North Hertfordshire District Council

Building Conservation comments

File Ref: 24/01582/FP & 24/01583/LBC

Subject: Alterations to covered oak frame structure providing external cover to courtyard area.

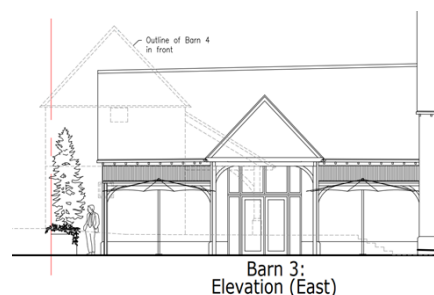
The current unauthorised covered structure sits between the listed barns and another grade II listed building that is the granary. The submitted Design & Heritage Statement says:

I previously inspected the way in which the structure abuts both buildings (see comments under refs: 23/02519/LBC & 23/02518/FP. I previously stated that the functional design and form, materials and scale of the existing structure are visually obtrusive, and the structure fails to respect the historic setting of Redcoats Farmhouse. I previously said that there would be a public benefit in facilitating and maintaining the effective and viable operation at Redcoats and in helping to secure a long-term viable future of these listed buildings and continued public appreciation of their agrarian historic interest. There are also economic benefits from employment opportunities in the business and local spend.

As stated in the DHS, *'the proposed alterations to the existing covered area is to remove the pitched section of roofing and the two sided thus producing a pagoda style structure giving a visual connection between the barns and the granary building. There is an infill with corrugated roofs either side of the gable structure. These will incorporate metal gutters that will be connected via new RWP to the existing soakaway drainage system. The pagoda structure will incorporate a material cover that can provide shelter in the wetter months. This will be incorporated within the structure and the cover will be designed to be retractable.'*

This is illustrated in the plan extract below. The corrugated roof lean-to's either side of the midstreys appear as outshuts and have an agrarian character whilst removing the apex of the tented structure will reveal the weatherboarded gable of the midstreys as originally intended.

1. The following items shall be removed within 6 months of the date of this decision notice:
 - i) The canvas covering to the existing structure as-built;
 - ii) The oak-framed gable structure above the pergola (which is retained under this consent); and
 - iii) The oak corner posts at the front of the structure as-built and which no longer serve a purpose in the scheme as hereby granted.

2. Details of the roof material for the lean-to's shall be submitted to and approved in writing by the Local Planning Authority prior to the commencement of that part of the development hereby consented. Thereafter the lean-to roofing shall be implemented in accordance with the approved details.

3. The new rainwater goods shall be black-painted metal or black metal-effect unless otherwise agreed and approved in writing by the Local Planning Authority.
